From: Sam HomanSent: Thursday, April 10, 2025 12:19 AMTo: Planning <Planning@a2gov.org>Subject: Thoughts on the Draft Comprehensive Plan

I've had a chance to go through the first draft of the comprehensive plan and wanted to share some thoughts.

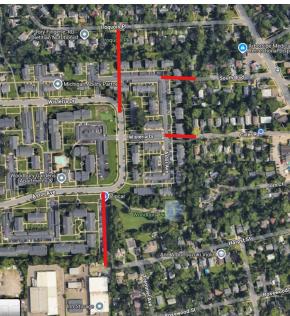
- No one actually wants to spend time along an arterial road, they just want to use it to get from place to place... and that's ok. The people and activity are just off Washtenaw and not on Washtenaw. My argument is that city and planning should embrace that observation rather than try to fight it.
- We can think of the parking lot that the retail Arbor Crossing surrounds as a sort of "town square" for that development. We may not like that it's a parking lot, but it is an active place.
- Consider a recent project that completely failed to activate an arterial road: The George.

• There's a lot of reasons this didn't work out as a retail location--the change in elevation really hurt it--but also the part of Packard it's on is definitely a road and not a street. So, any retail here was never going to get meaningful foot traffic. But what if instead of trying to activate Packard, the site had tried to activate Page Avenue on the other side of the building?

- I could see neighborhood retail working here. Particularly, if some "place making" effort had gone into trying to make this area around Page Avenue a village square for the Georgetown neighborhood.
- Two areas by me that I think the plan should call out for building "Village" squares around (i.e. "place making") are: Page Avenue between Pine Valley and King George and in the middle of the center block of Woodbury Gardens. A really nice "village plaza" could be developed there if the complex is fully redeveloped.

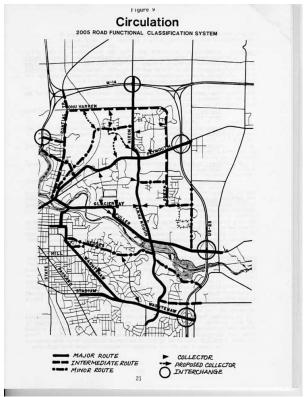
- The Ponds park (the playground section) is placed on top of the right of way for Candlewick Dr and seems designed to ensure Candlewick and King George never connected.
- Meadowbrook Park is placed at the end of 7<sup>th</sup> street and seems designed to ensure 7<sup>th</sup> street and Meadowbrook Apartments are never connected.
- The 1989 North East Area Plan called for the abandonment of Huron Parkway to M14 so that Huron Parkway wouldn't go through Leslie Golf Course:

"This plan recommends revision of the Huron Parkway "inner belt" concept, making use of existing roads to serve future development in the northwest portion of the study area and minimize disruption to Leslie Golf Course and adjacent residential developments"

• But it did suggest that Tuebingen Parkway be extended to Dhu Varren Road as an alternative to Huron Parkway. Except...Tuebingen Parkway was abruptly ended by Placid Way Park
